Modifications Document

REA Number 0300-8UQPKR

Grand Renewable Wind Project

NEW PLANTING LOCATION
FIGURE 3

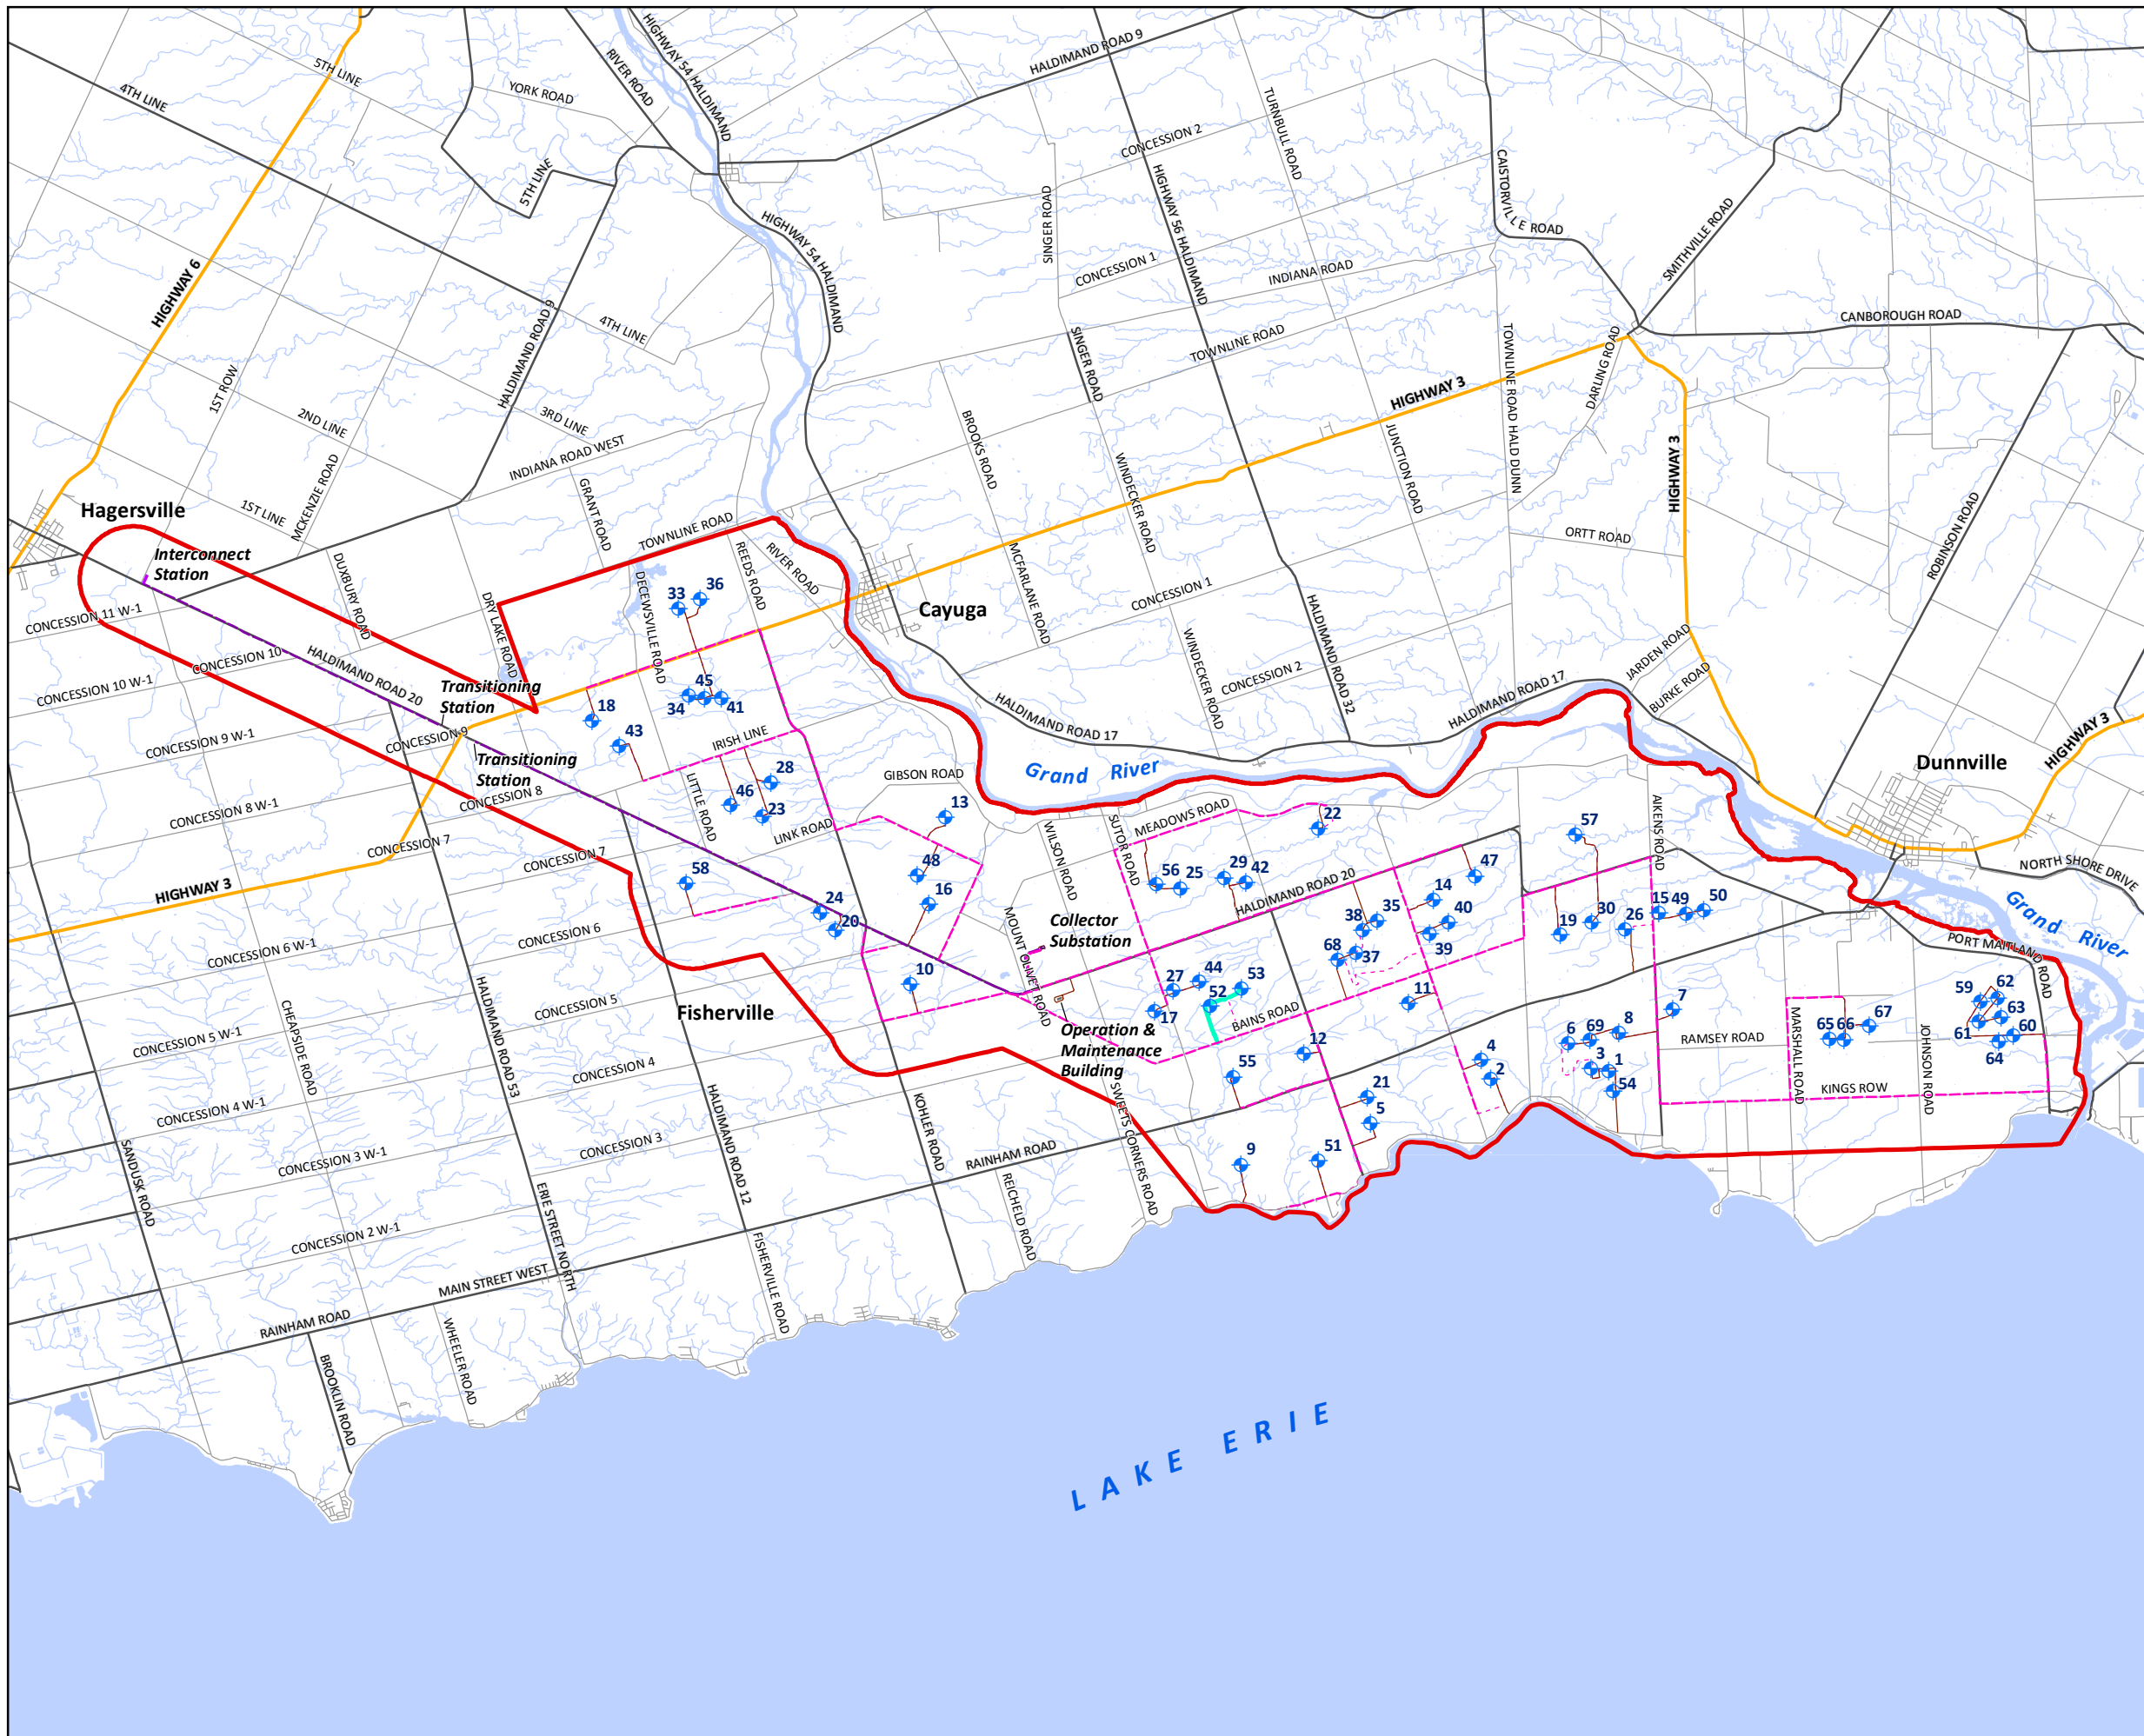
The planting location is now being proposed to the south of Turbine 9 (see **Figure 3 in Appendix A**) within a narrow area of cultural meadow and adjacent to an existing mixed plantation (see **Appendix G** for the ELC map included in the original NHA). The benefits of this planting location include:

Figure No.
6.8

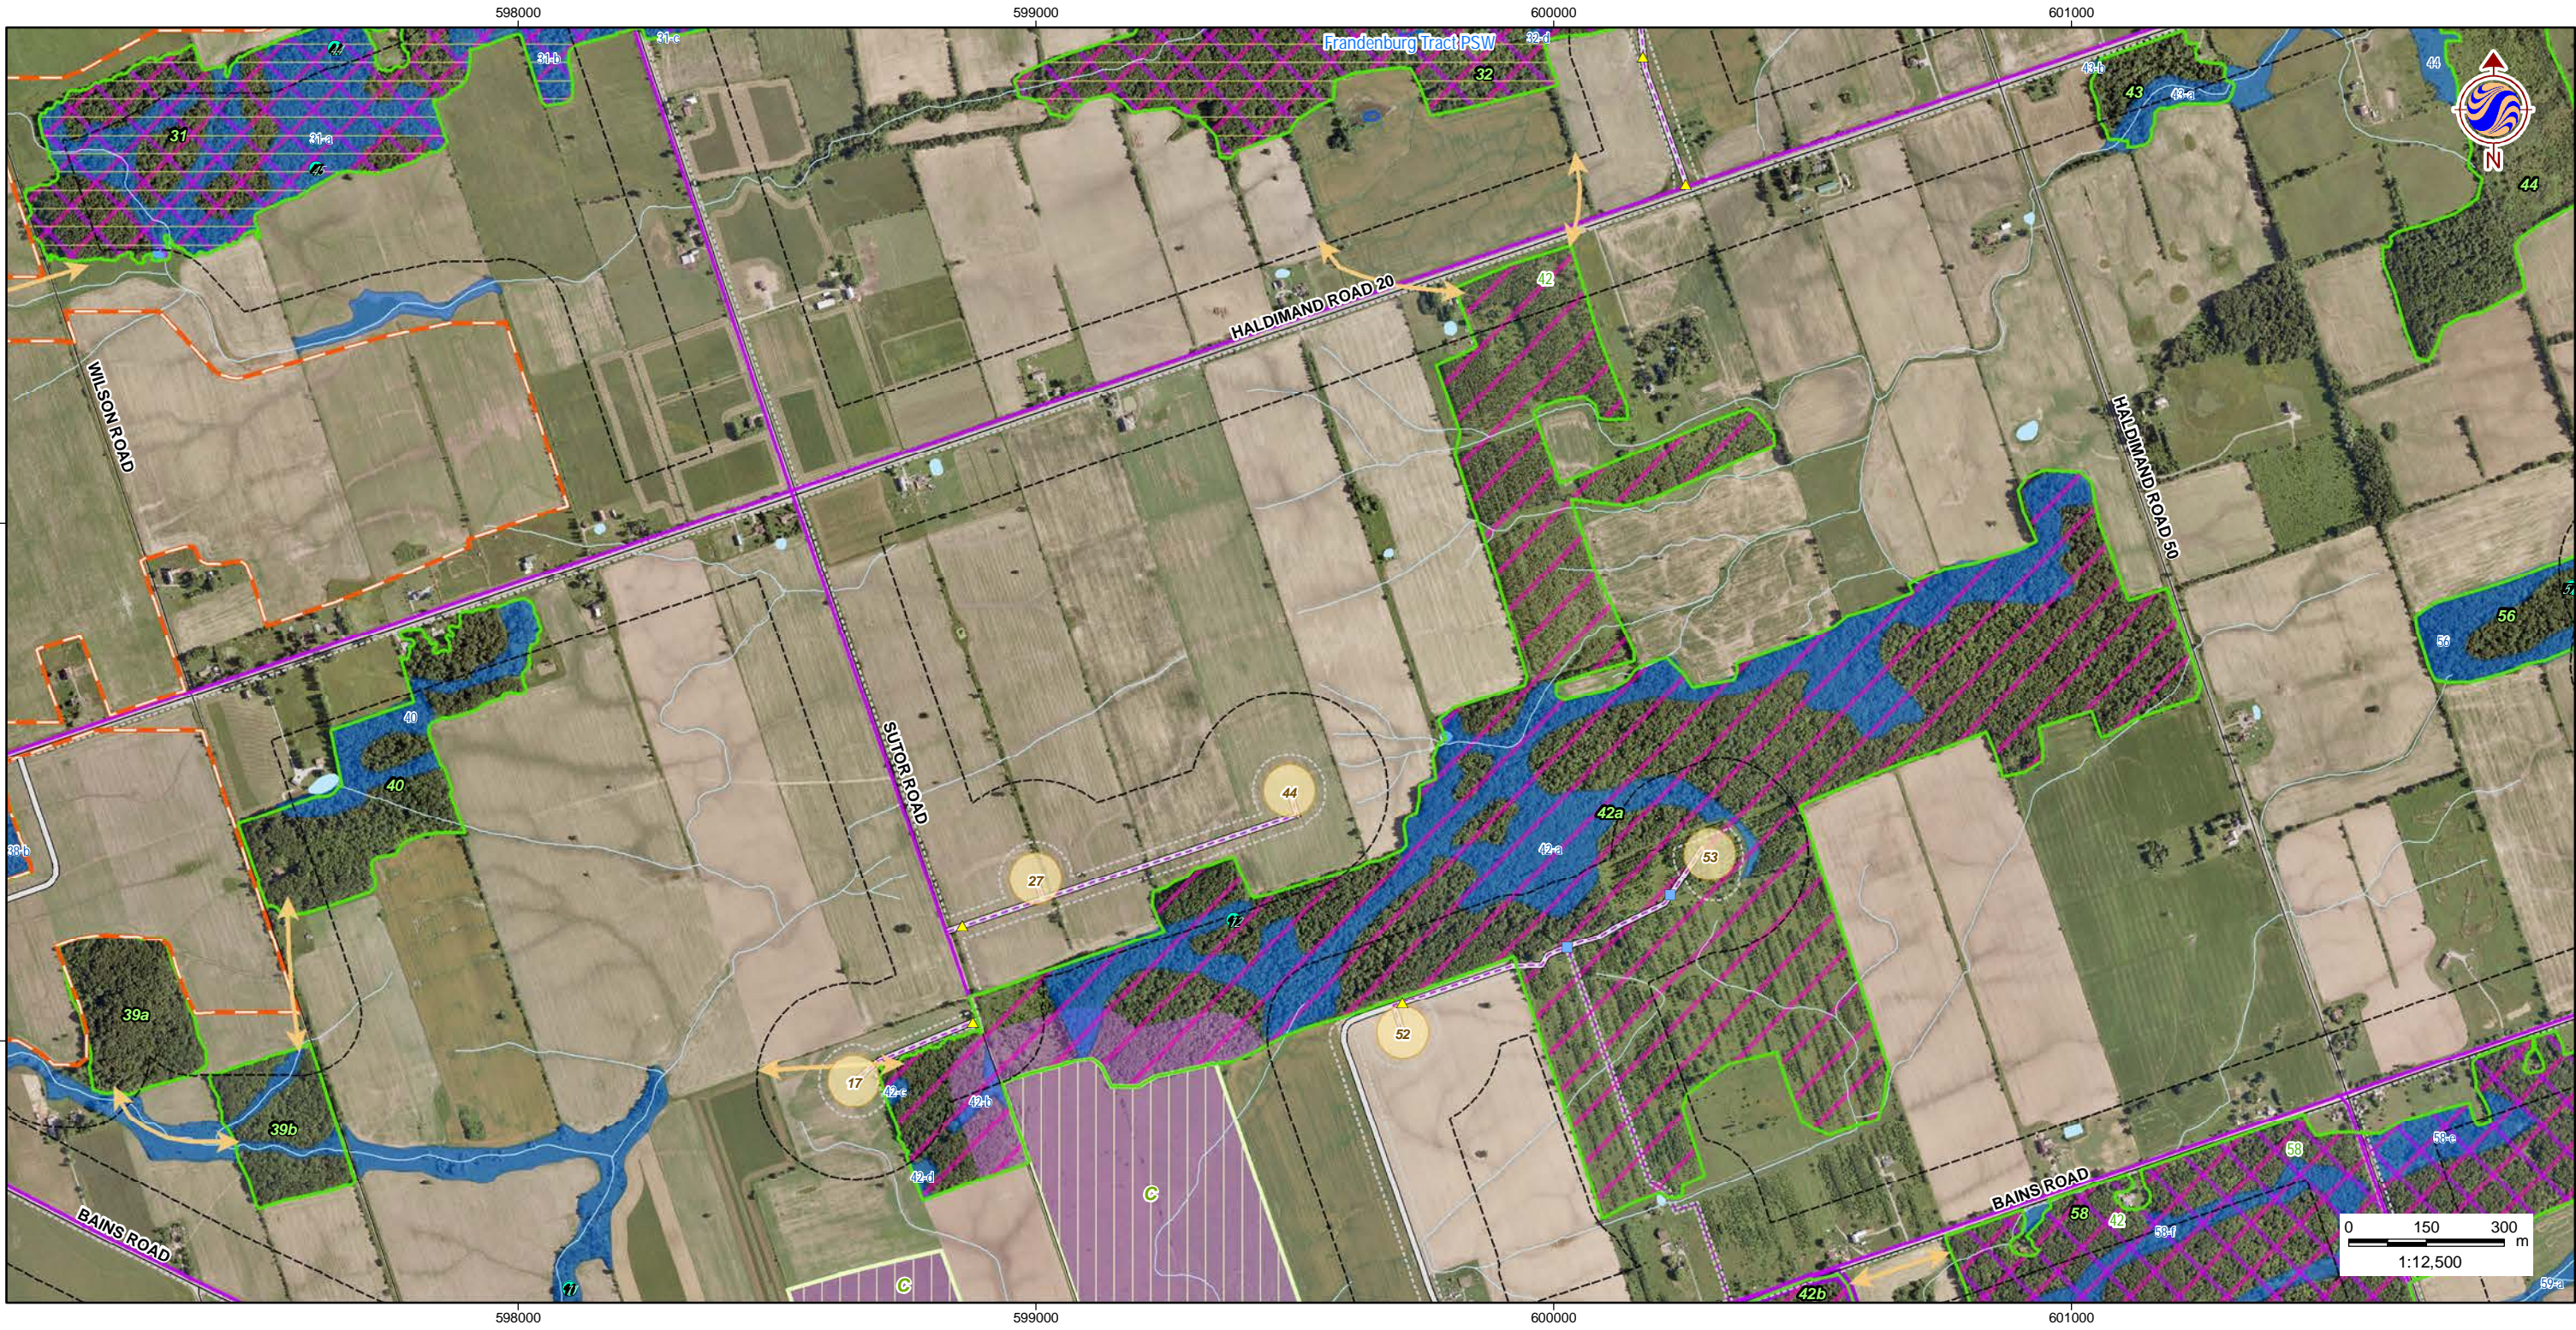
Report Section	Text To Be Modified	Overview of Modification
	modified.	
8.0 References Cited	The proposed amendment does not require any text to be modified.	Not applicable.
Appendix A: Figures	Figure 6.8: ELC Vegetation Communities – W8	Figure 6.8. The area labeled as CUP3-12*A to the south of Turbine 53 and its associated access road (outside of the Wind Project Location) was removed by the landowner. In 2014 the land was observed by Dillon Consulting to be cleared, grubbed and is expected to be used for agricultural farming. This area no longer meets the commitment outlined in Section 6.1.19.3 for tree compensation planting.
Appendix B: Tables	Table 6.1 (Page 12 of 25). Row for Natural Feature 42 related to Habitat for Declining Species. Under Mitigation Measures: <i>“Plant additional trees throughout the plantation to offset construction loss.”</i>	Revise text indicated to read: <i>“Plant additional trees <u>in open field area to the south of Turbine 9.</u>”</i>
